U. S. ATOMIC ENERGY COMMISSION

REPORT TO ADVISORY COMMITTEE ON REACTOR SAFEGUARDS

INDIAN POINT NUCLEAR GENERATING UNIT NO. 2

REPORT NO. 3

Figure 6 - Indian Point II Containment Capability Curves  
Allowable Metal-Water Reaction At a Given Time Without Exceeding  
Containment Pressures of 47 or 60 psig

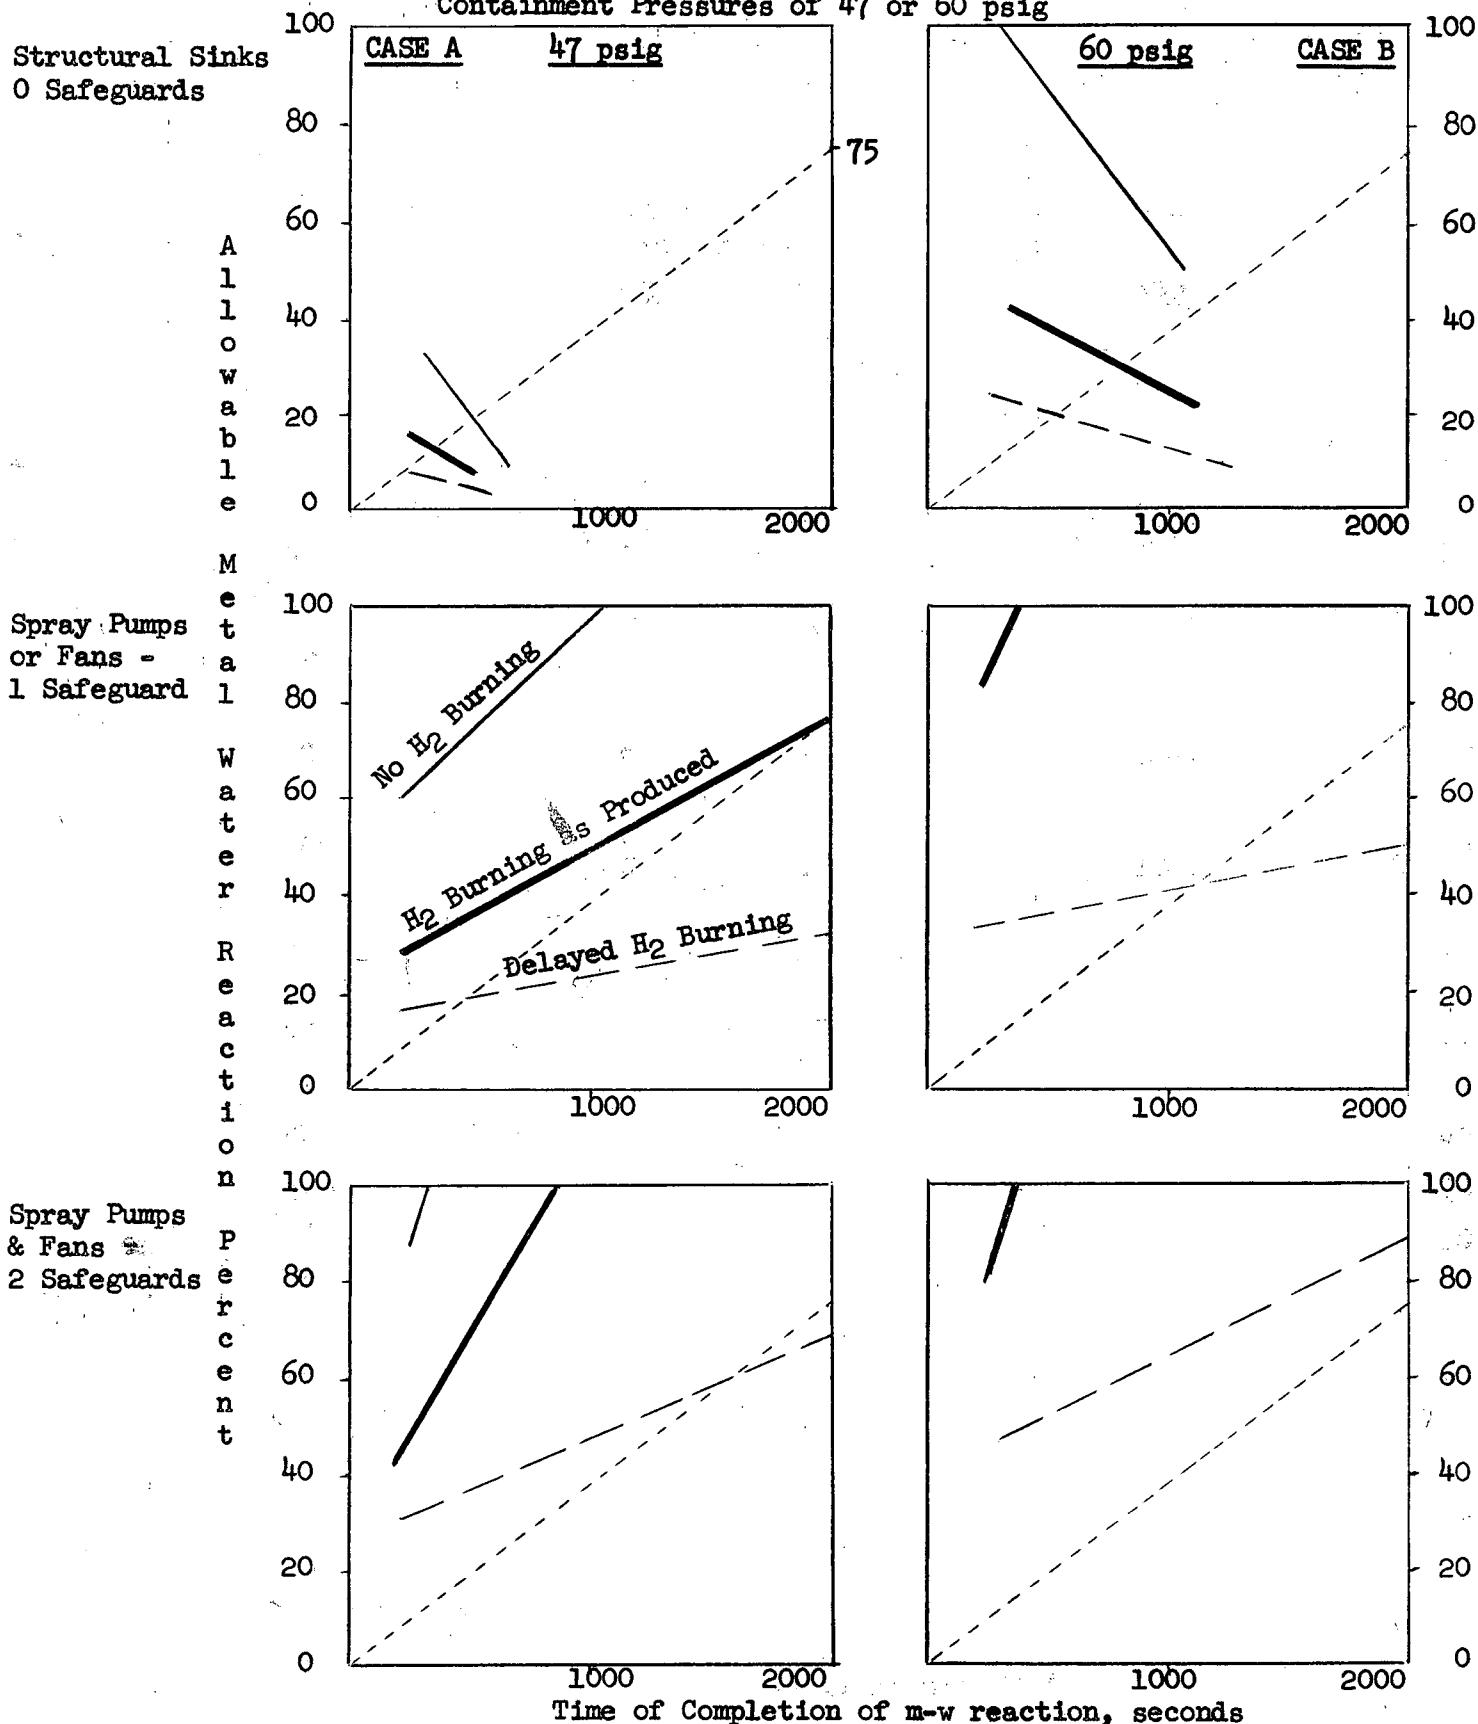
To assist in evaluating the Indian Point 2 containment pressure design we have prepared Figure 6 which is an attempt to present the overall containment capability picture. The values have been obtained using our proposed model as discussed previously and are presented in the form of allowable metal-water reaction that causes the containment pressure to reach a defined pressure versus the time to complete the reaction. The dotted line is the Staff's assumed m-w reaction rate. For the 47 psig design case, where a plotted value for Indian Point 2 lies above this line, the containment pressure design would be considered adequate since the tolerable m-w reaction to prevent exceeding design pressure is more than the amount of reaction assumed possible. We have also included for completeness the cases of no hydrogen burning and for delayed hydrogen burning although we believe the later case, especially for complete delayed burning, is highly improbable based on both mixing and stoichiometric requirements.

It should be recognized at this point that the use of the decay, stored, and steam generator heat sources is somewhat conservative and if none of these energy sources were added to the containment atmosphere the allowable m-w reaction would increase by 40%. In fact, these energy sources and the choice of the metal water reaction rate are the areas of conservatism in our evaluation. The significant observations from Figure 6 for Case A (47 psig) are,
